# Access Compliance Report

## Public Rights-of-Way

Intersection ID: 48073	Main Street: MALLARD_HIGHLANDS_DR	Cross Street: MALLARD_GLEN_DR	Location: S
ADA ID: 0AE72E9F8DAD	Ramp Type: PerpDiag	Initial Pass/Fail: Fail	Overall Compliance: No
Severity Score: 46.25			
Codes/Mitigation Info/Possible Solution		Field Measurements/Component Compliance

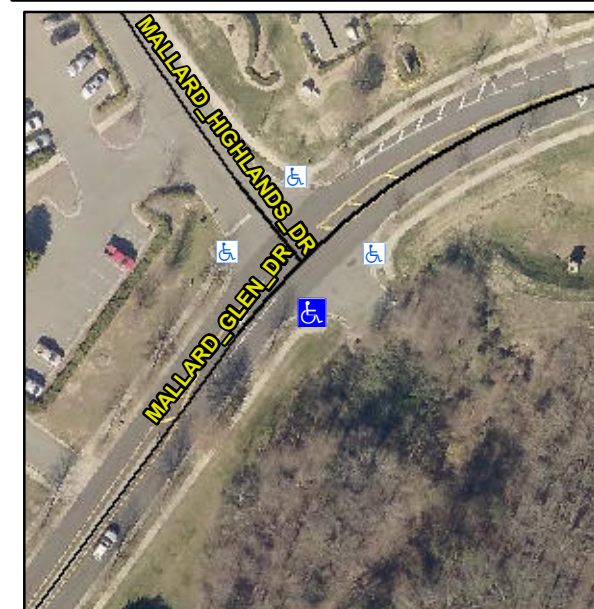
**Remove & Replace Curb Ramp With Two New Directional Ramps or Equivalent.**

**R304.5.1, R304.2.2, R304.5.3**

Compliance	Description	Data	Compliance	Description	Data
N/A	Ramp Length (in)	62.0	No	Ramp Slope (%)	11.0
No	Ramp Width (in)	41.0	No	Ramp XSlope (%)	7.6
N/A	Flare Type LT	N/A	N/A	Flare Type RT	N/A
N/A	Flare Slope LT (%)	N/A	N/A	Flare Slope RT (%)	N/A
N/A	Flare Traversable LT?	N/A	N/A	Flare Traversable RT?	N/A
N/A	Landing Length (in)	N/A	N/A	DWS Provided?	N/A
N/A	Landing Width (in)	N/A	N/A	DWS Contrast?	N/A
N/A	Landing Slope (%)	N/A	N/A	DWS Length (in)	N/A
N/A	Landing X Slope (%)	N/A	N/A	DWS Full Width?	N/A
N/A	Landing Curb? (Y/N)	N/A	N/A	DWS Offset (in)	N/A
N/A	Shared Landing?	N/A			
N/A	Gutter Ponding?	N/A	N/A	Gutter Slope (%)	N/A
N/A	Gutter Lip Ht (in)	N/A	N/A	Gutter X Slope (%)	N/A
N/A	Painted X Walk1?	No	N/A	Painted X Walk2?	No
	X Walk 1 Direction	To NE		X Walk 2 Direction	To NW
N/A	X Walk 1 Width (in)	N/A	N/A	X Walk 2 Width (in)	N/A
	X Walk 1 Slope (%)	3.8		X Walk 2 Slope (%)	6.0
	X Walk 1 X Slope (%)	5.1		X Walk 2 X Slope (%)	0.4
